# NON-MATERIAL AMENDMENT APPLICATION

November 2020  
Doc Ref. 682.SD.005B

Planning Permission 2018/5462/P NMA Document

Non-Material Amendment application document for planning permission 2018/5462/P (erection of 4x 3-storey, 3-bedroom dwelling houses with associated landscaping following demolition of existing 3x single storey garages.)

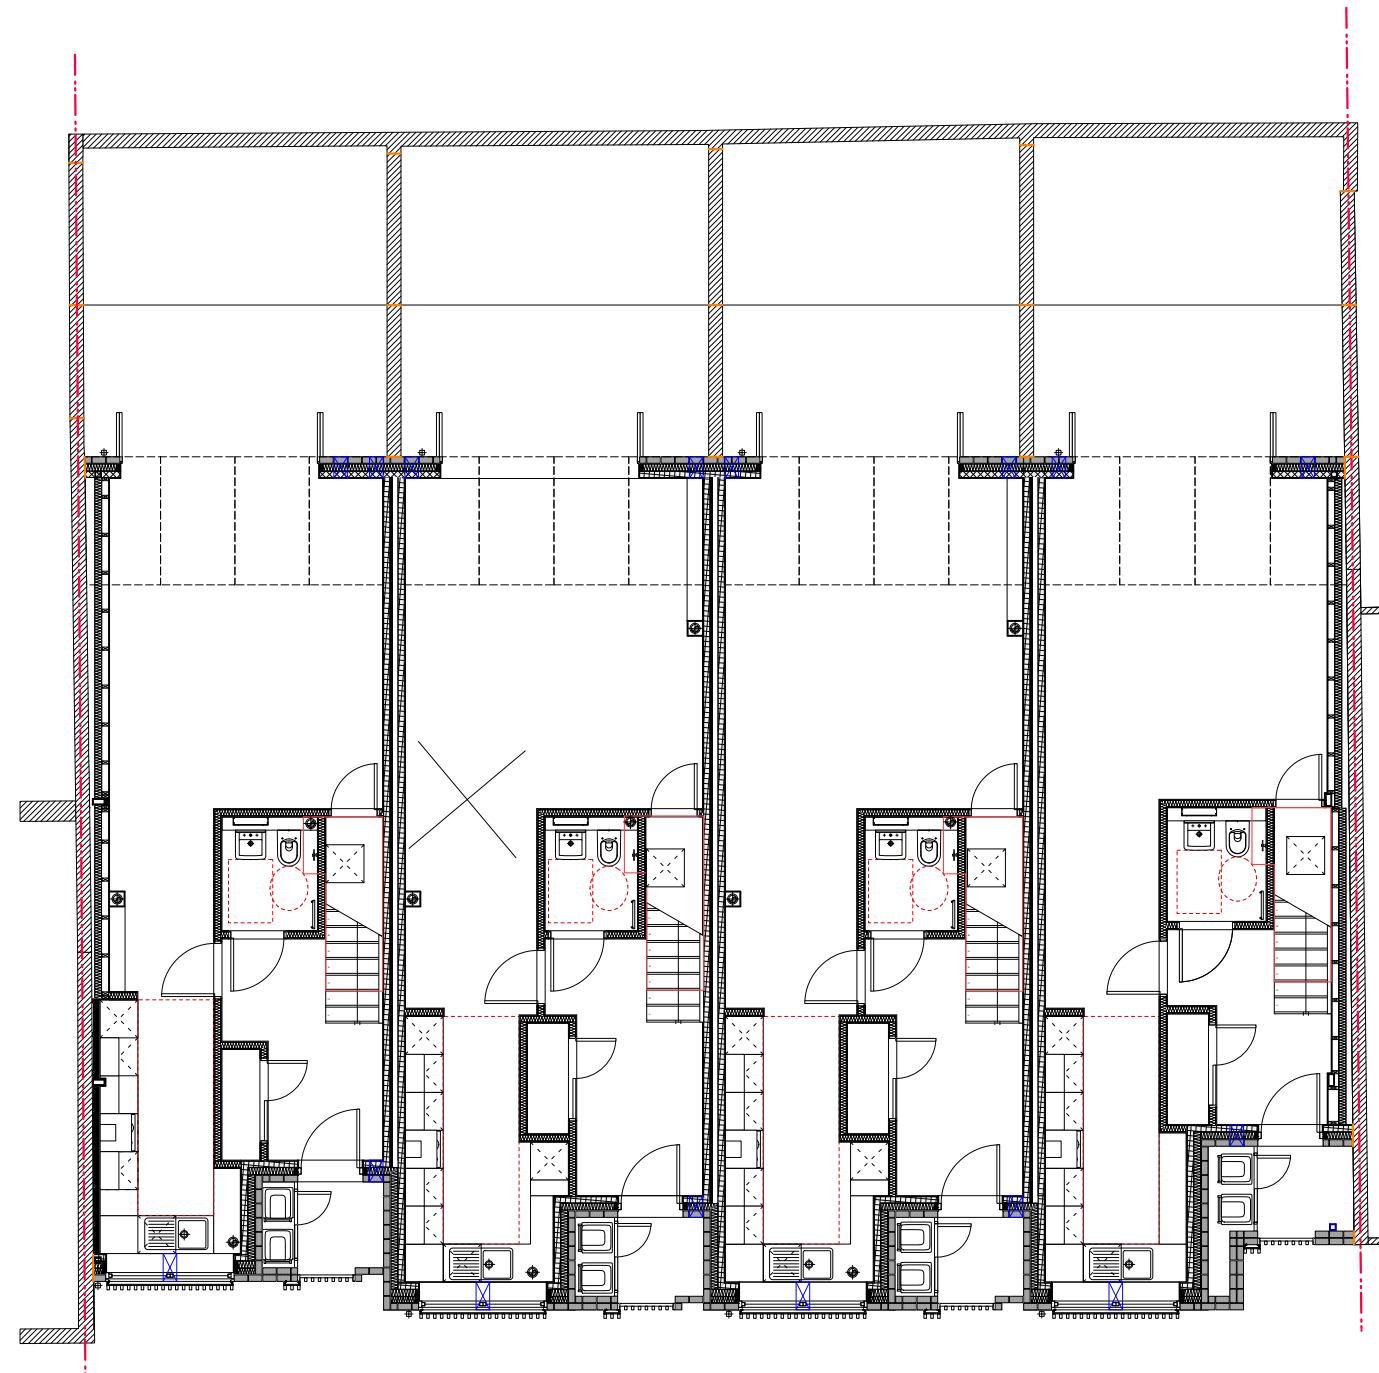
- NOTE: Amendments shown on elevation. Other general changes include:
- Minor changes as a consequence of brick setting out and post-site-clearance measured survey.
  - Minor changes to layouts so to comply with building regulations.
  - General minor alterations throughout to ensure scheme works as per planning scheme.

NB: LOCATION OF 2F WINDOWS MATCH THOSE SHOWN ON EXTANT PLANNING PLANS

01 PROPOSED FIRST FLOOR PLAN

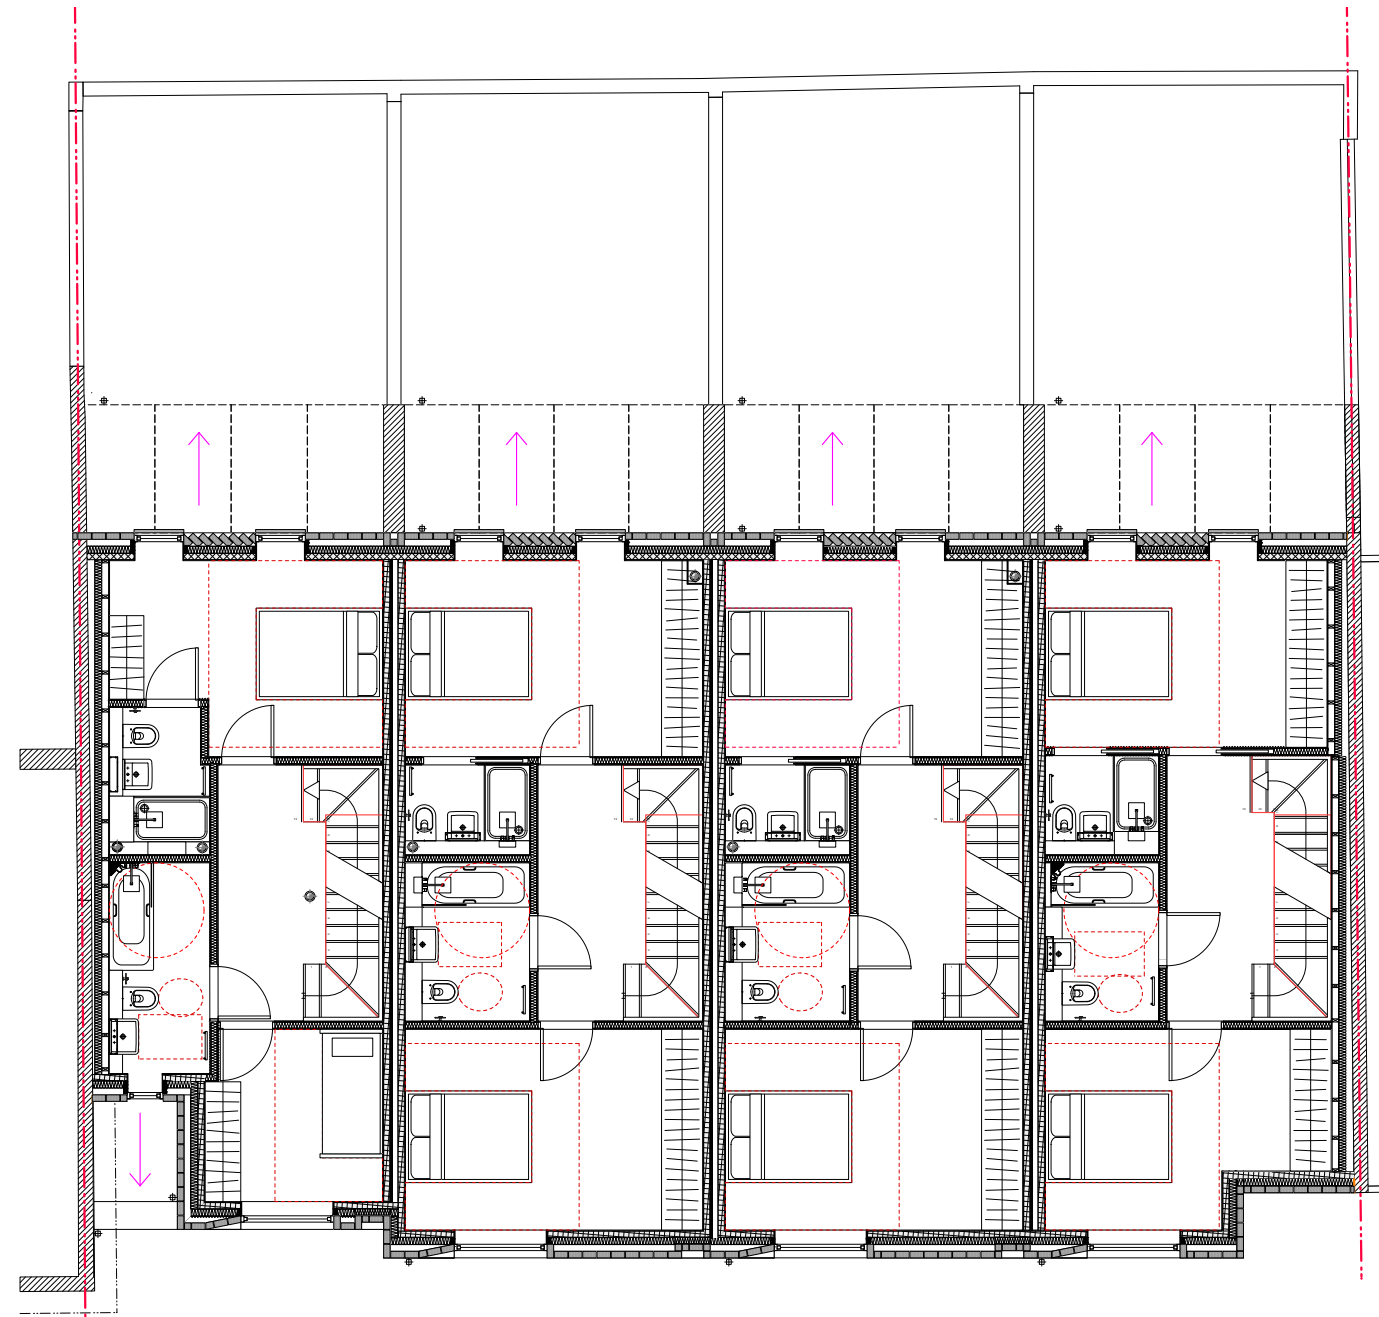
- Minor changes as a consequence of brick setting out and post-site-clearance measured survey.
- Minor changes to layouts so to comply with building regulations.
- General minor alterations throughout to ensure scheme works as per planning scheme.

01 PROPOSED SECOND FLOOR PLAN

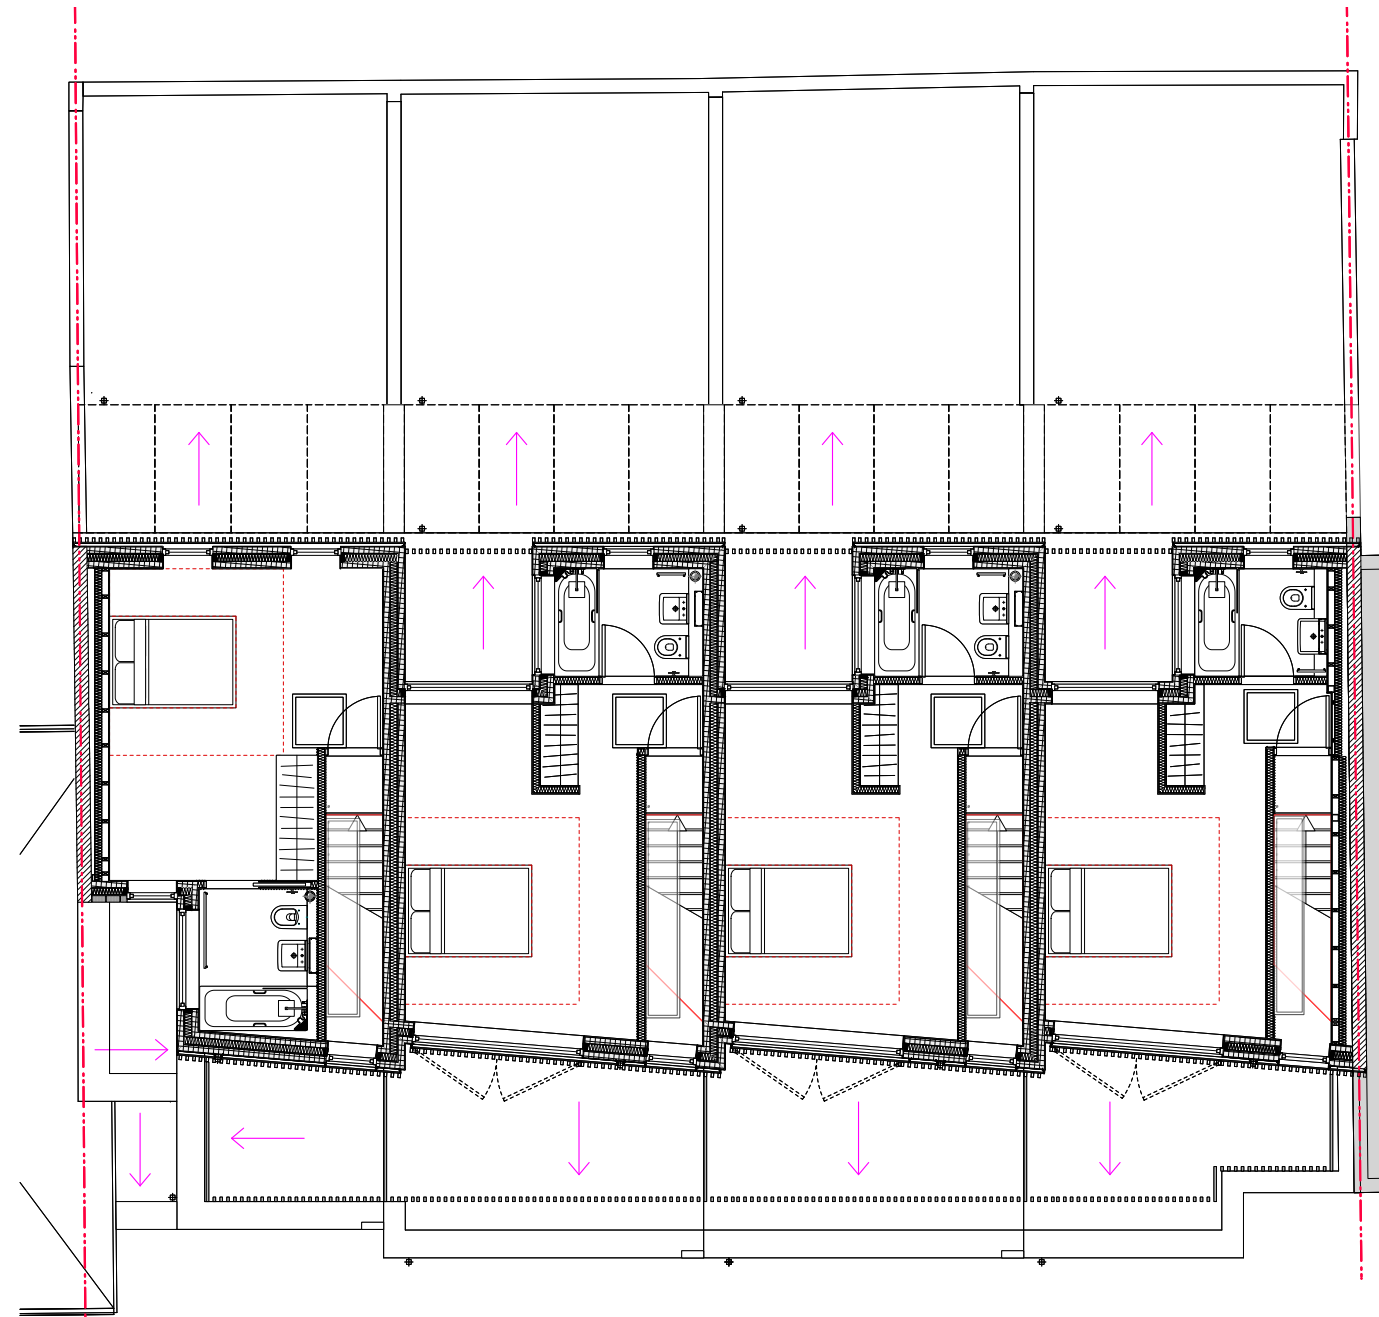
- Minor changes as a consequence of brick setting out and post-site-clearance measured survey.
- Minor changes to layouts so to comply with building regulations.
- General minor alterations throughout to ensure scheme works as per planning scheme.

01 PROPOSED ROOF PLAN

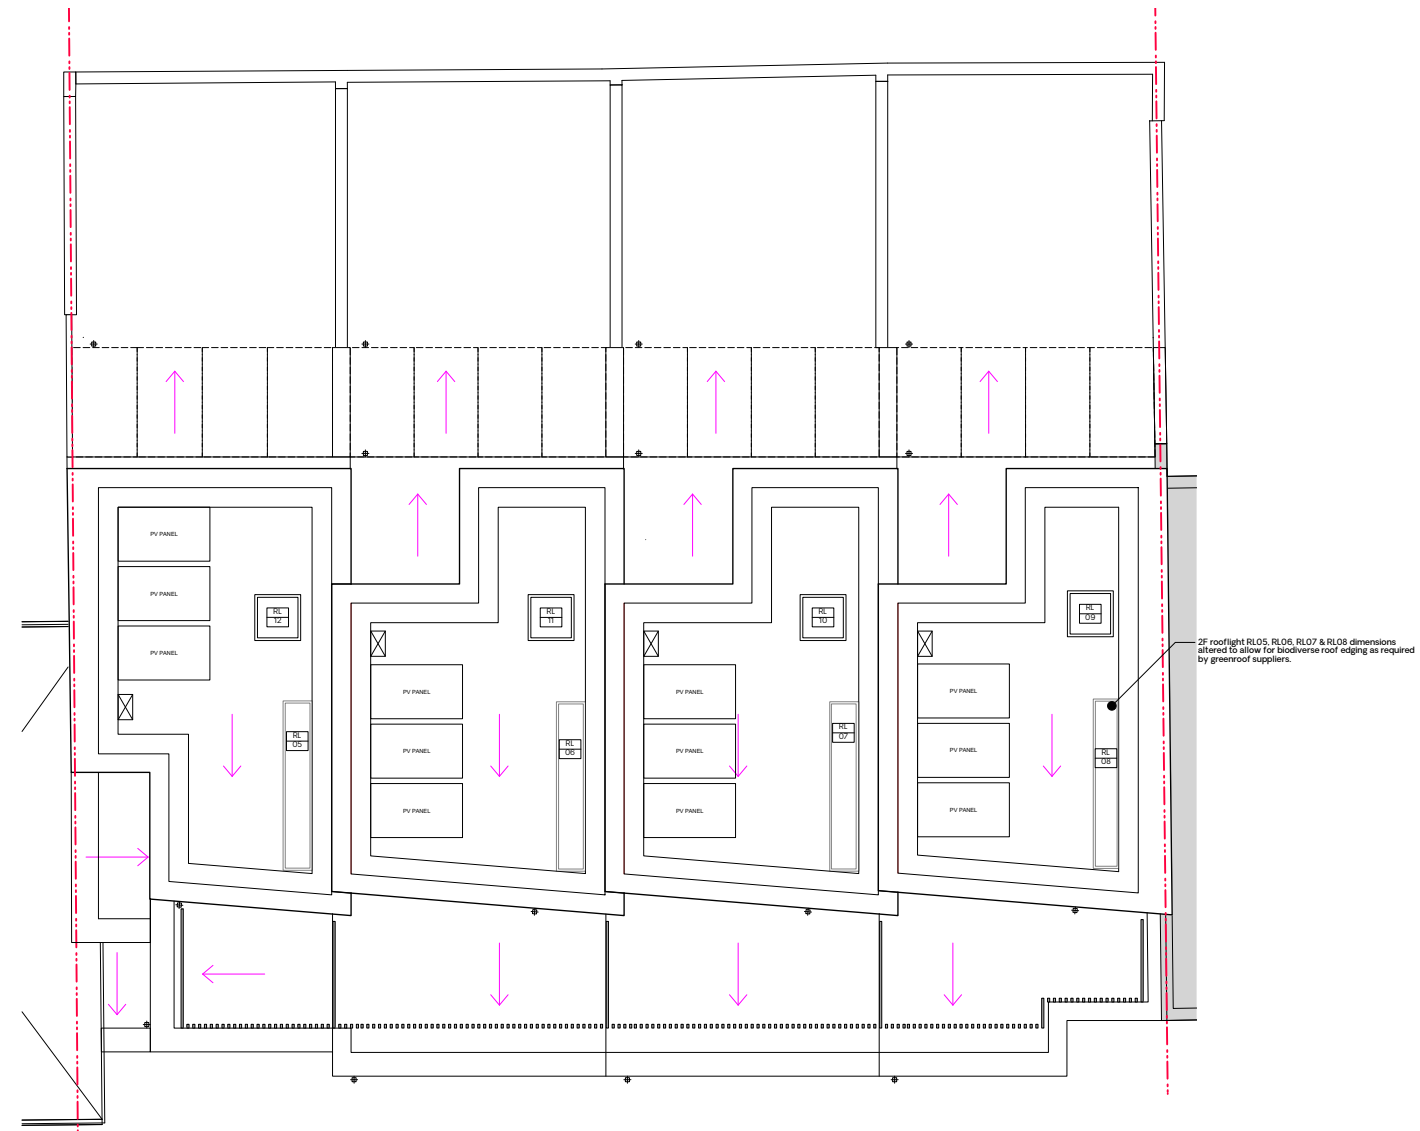
- Minor changes as a consequence of brick setting out and post-site-clearance measured survey.
- Minor changes to layouts so to comply with building regulations.
- General minor alterations throughout to ensure scheme works as per planning scheme.
